ADDENDUM NUMBER 1

**Professional Development Center
and Kitchen**

For
SAN BERNARDINO CITY UNIFIED SCHOOL DISTRICT
Bid No F16-05

December 28, 2015

11 ENLARGED SITE PLAN - DEMO
1" = 10'-0"

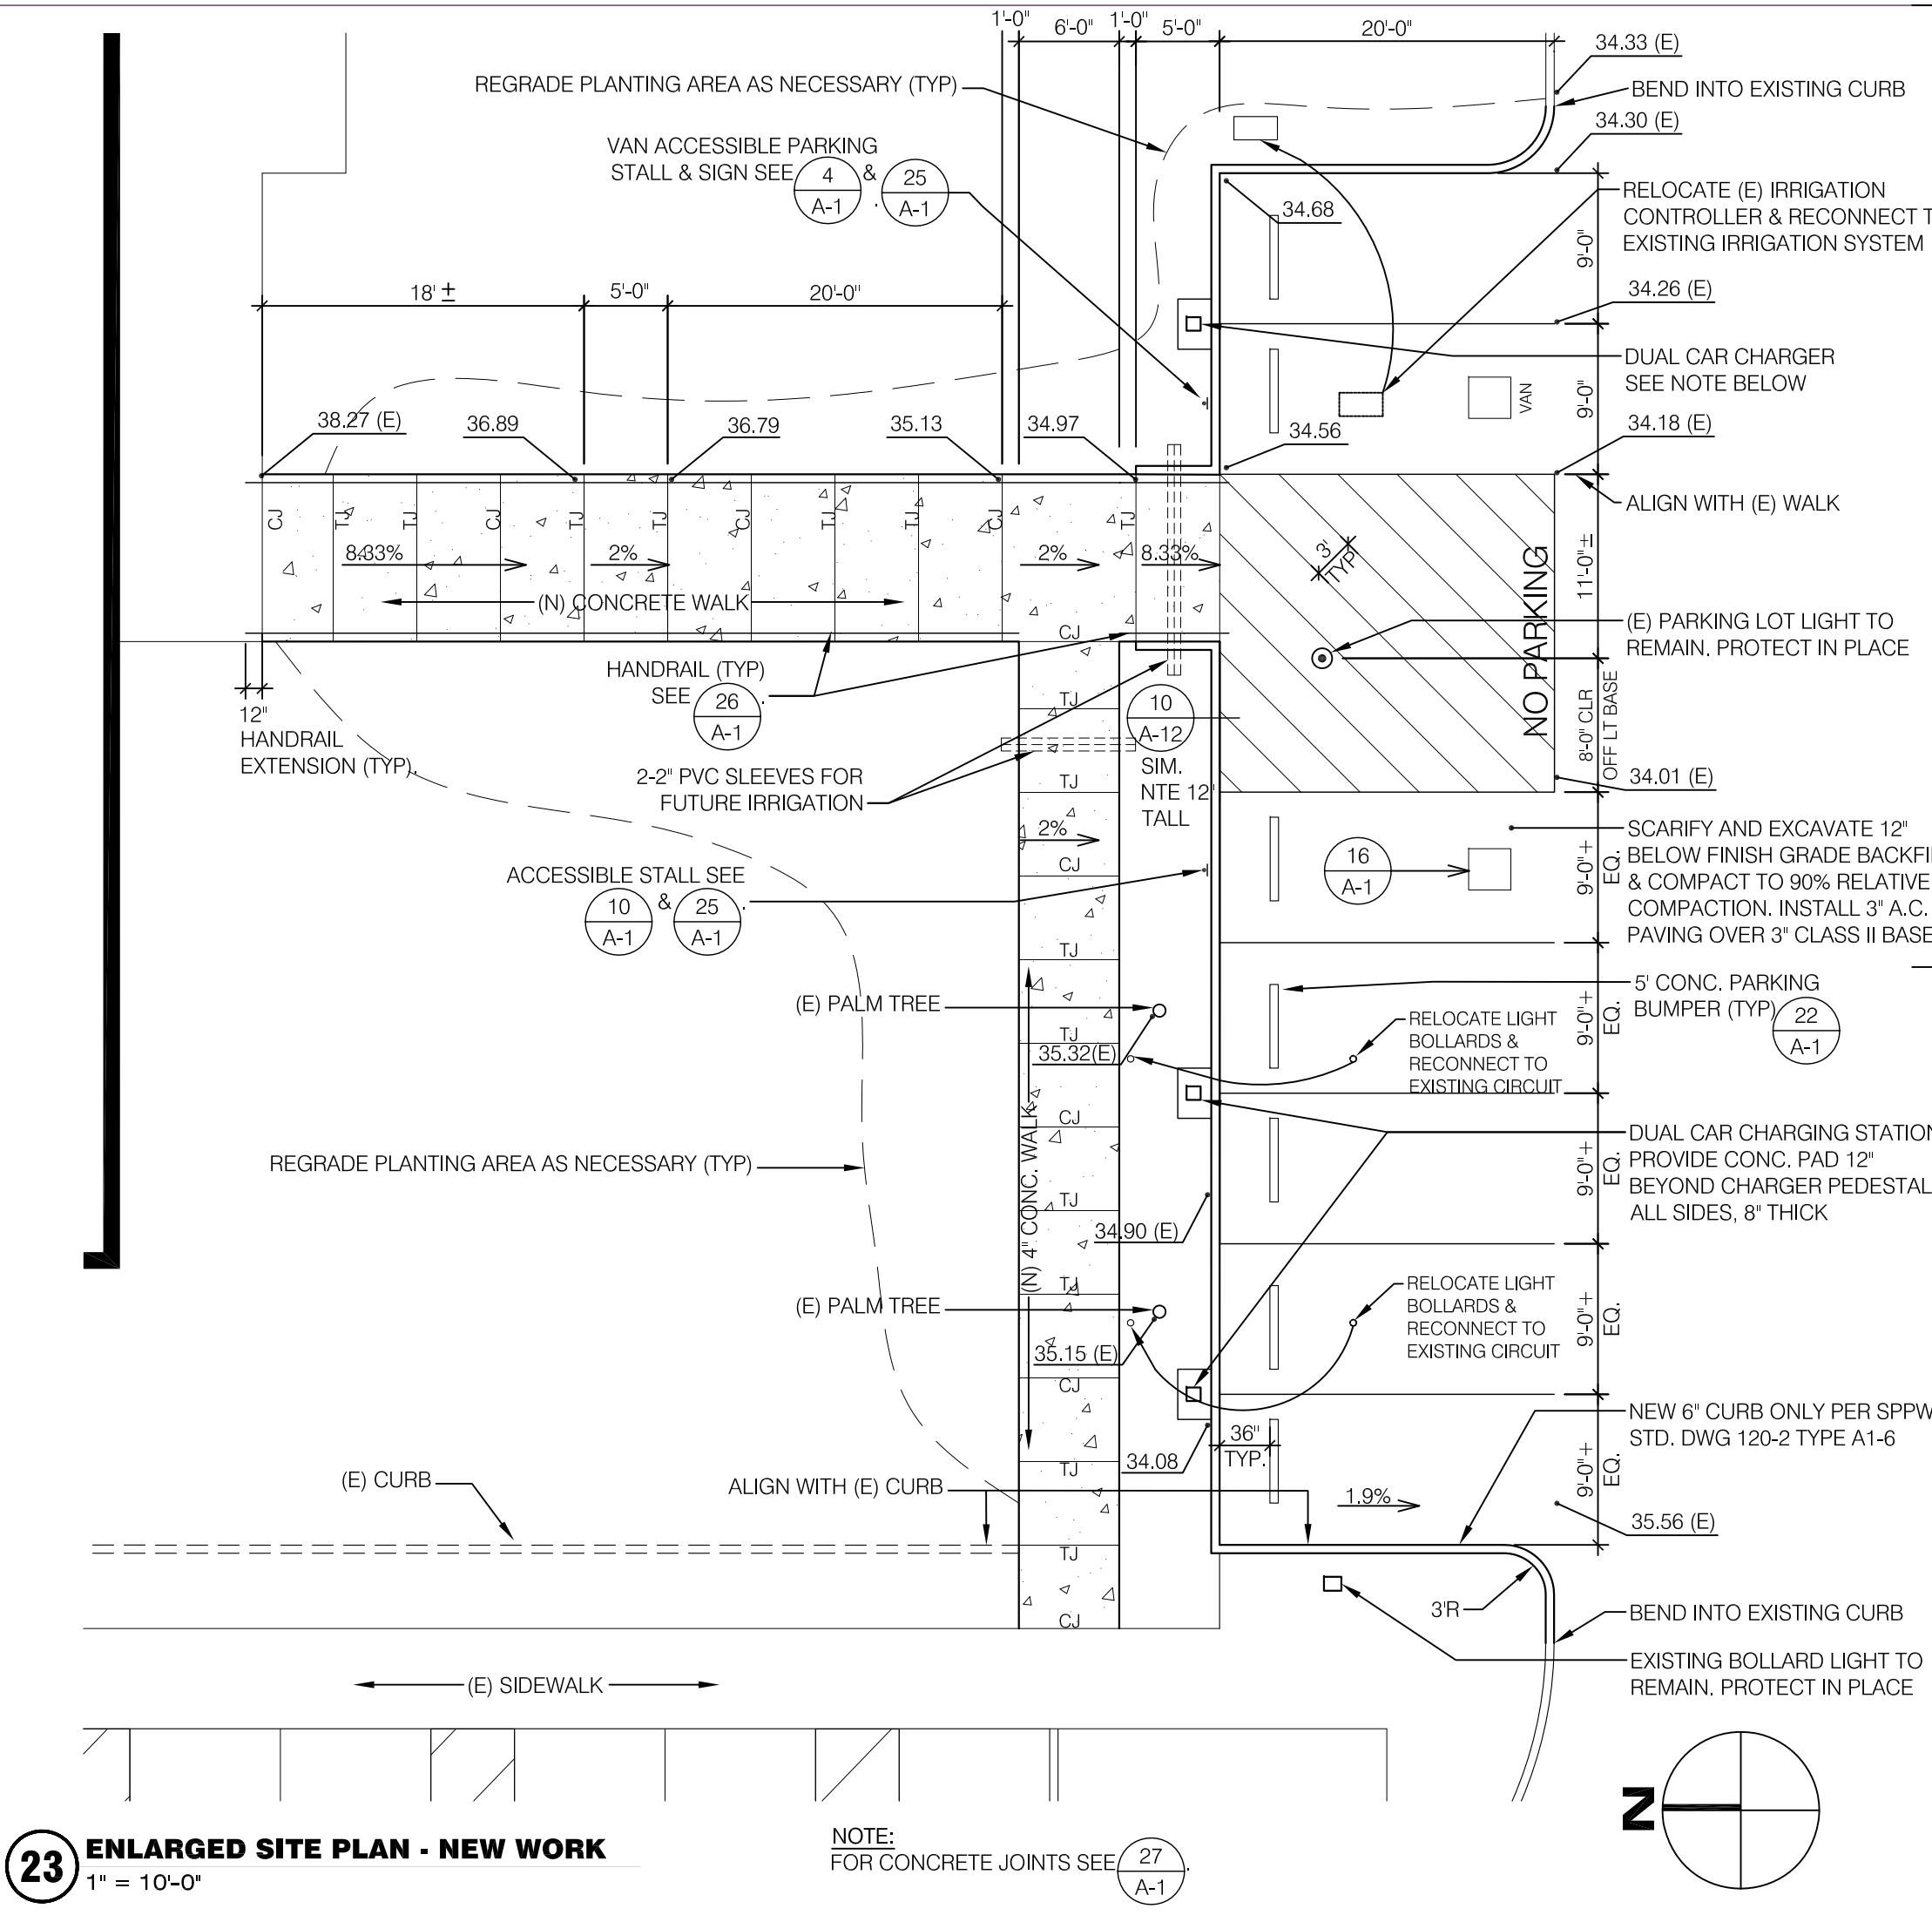
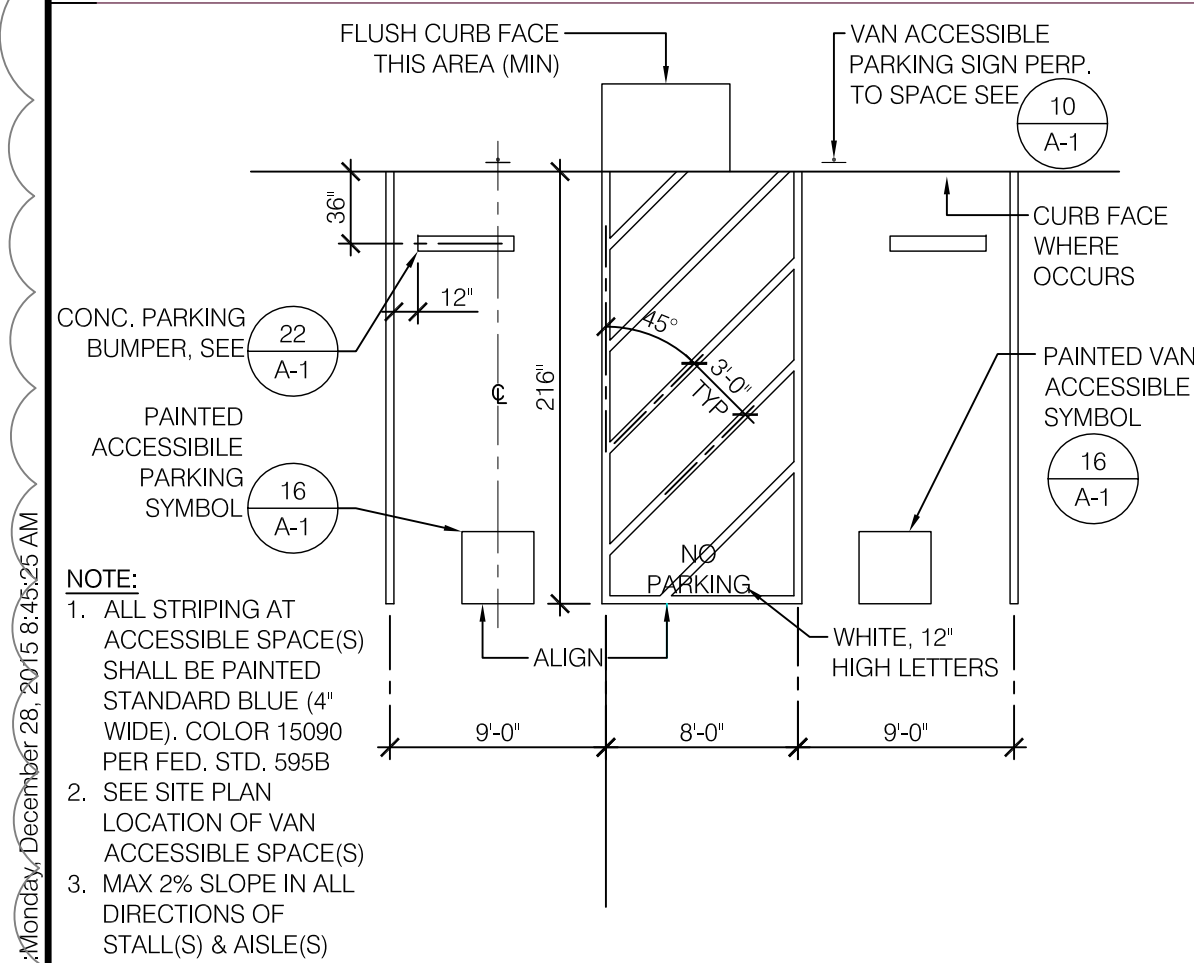
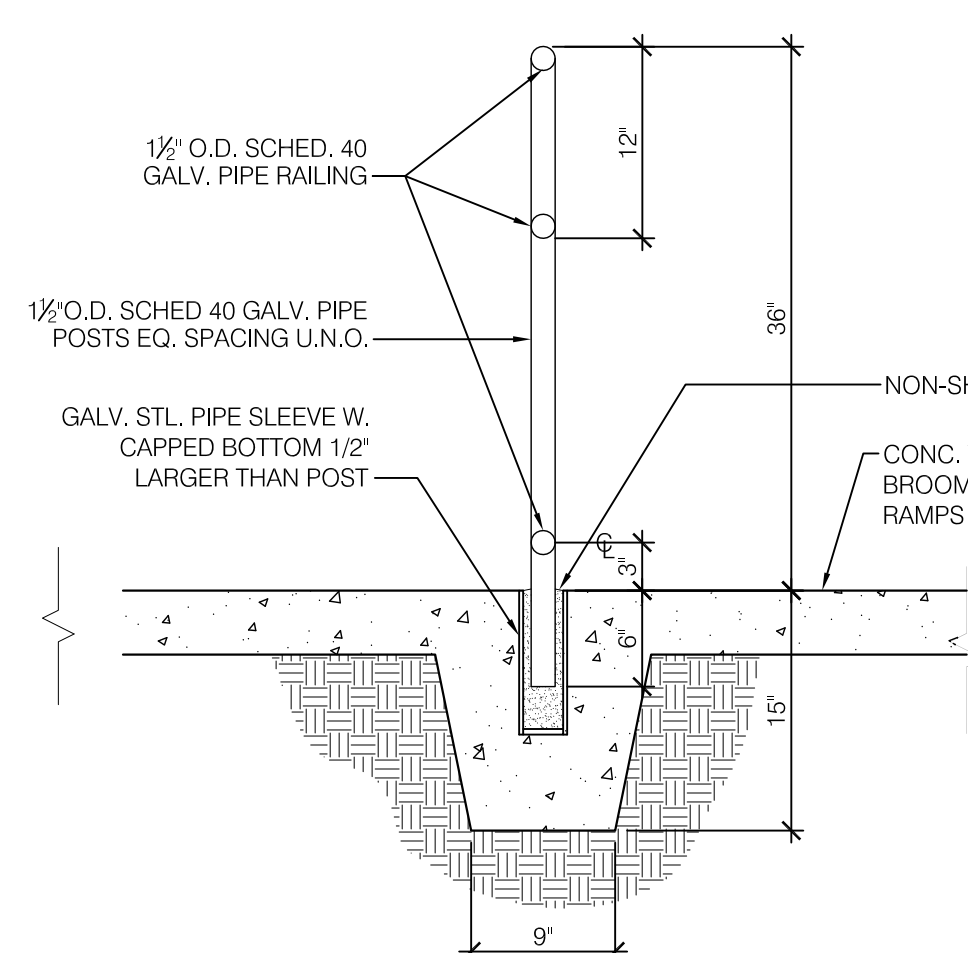
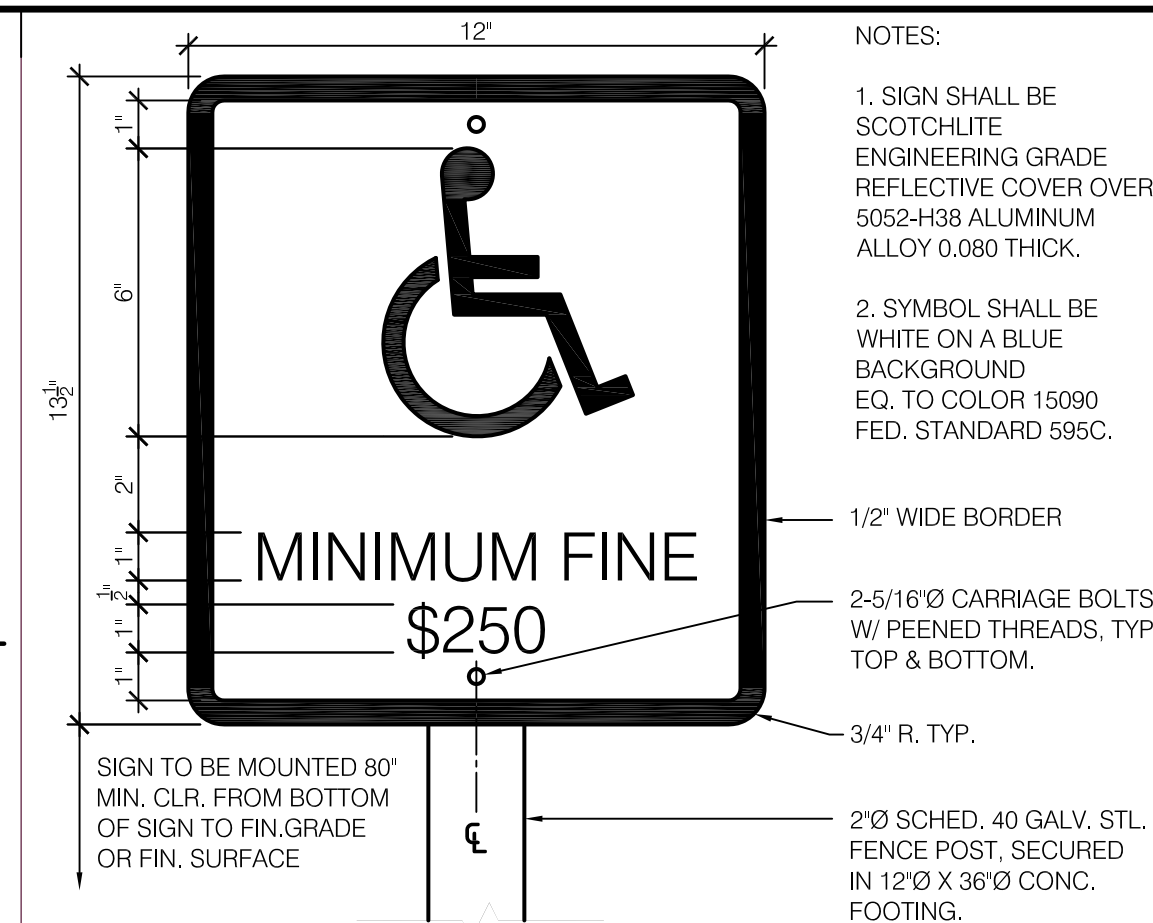
Item Number 19; Reference: Sheet A-1, Site Plan; Replace this sheet with attached sheet **A-1, Site Plan,**

Note: Revised sheet provides clarification on parking expansion, car charging stations and associated site modifications and adds details 4,10,11,16, 22,23, 25,26 and 27.

FIRST FLOOR
REFLECTED CEILING
PLAN

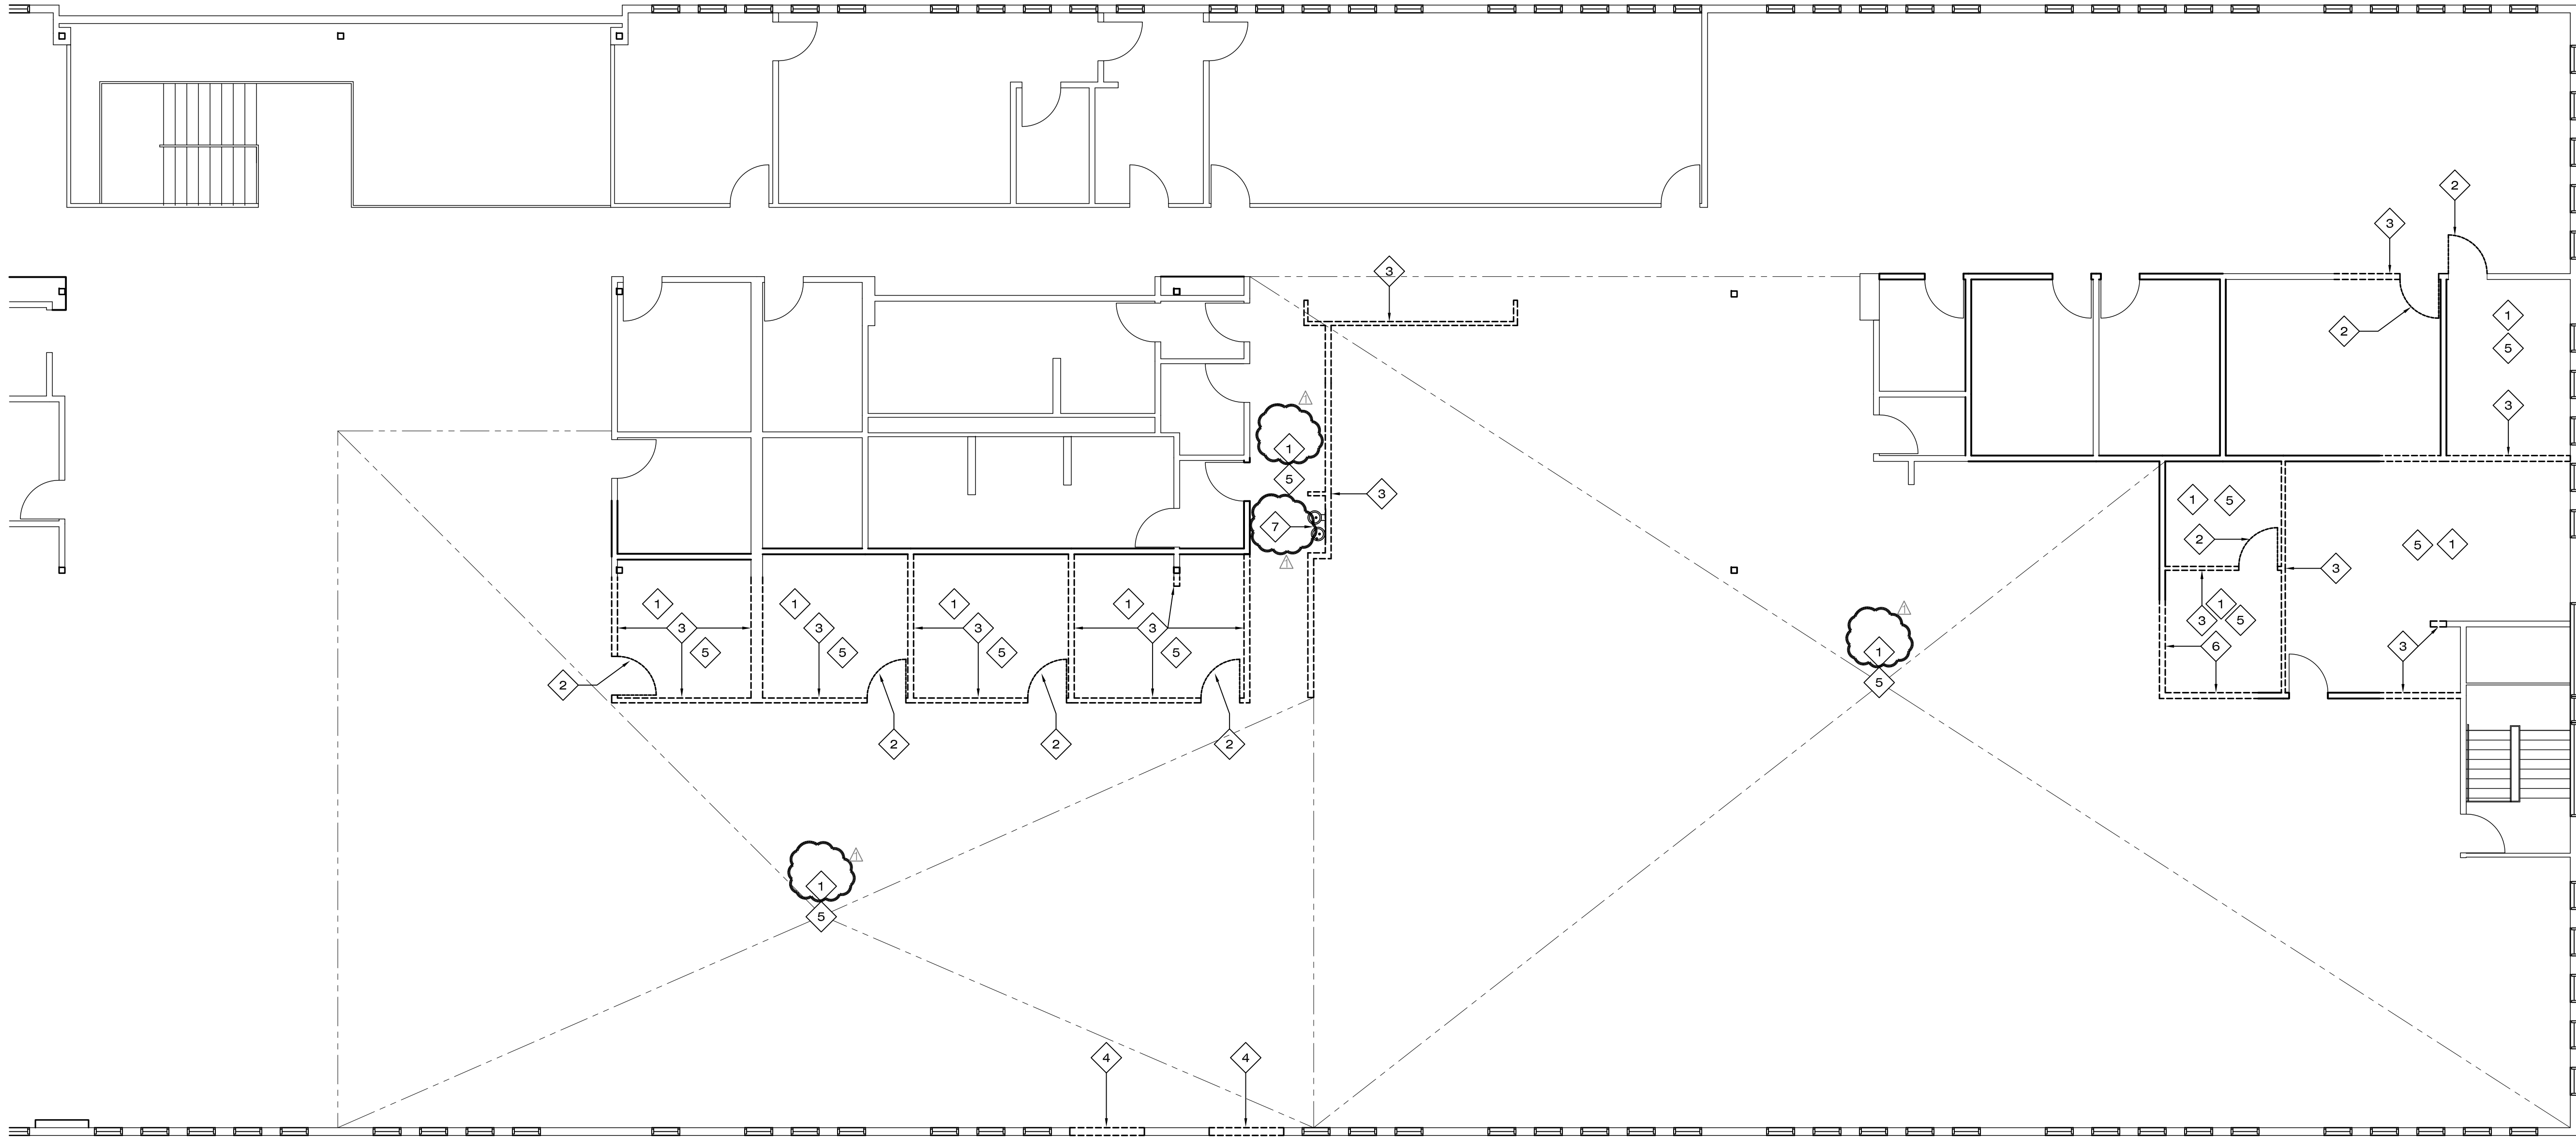
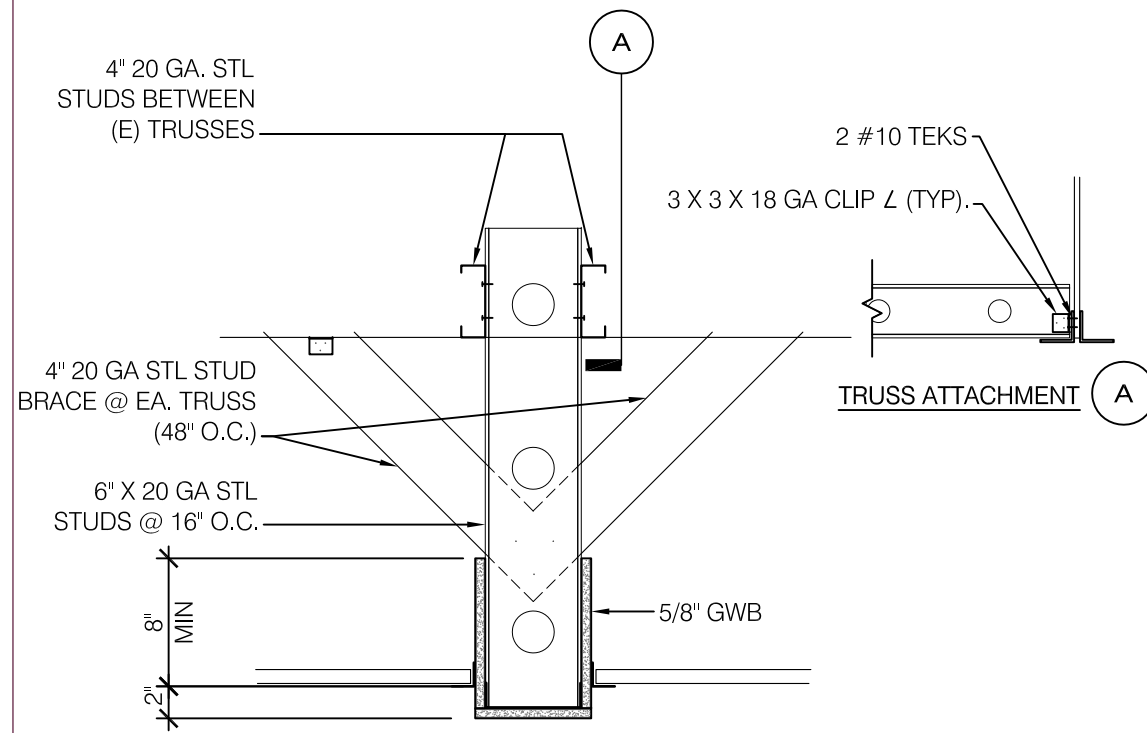
Item Number 21; Reference: Sheet A-4, First Floor Reflected Ceiling Plan; Replace this sheet with attached sheet **A-4, First Floor Reflected Ceiling Plan**

Note: Revised sheet provides clarification of ceilings in Break Areas A105 and A107 and division soffit in Cafeteria A101, adds General Notes and adds detail 23.
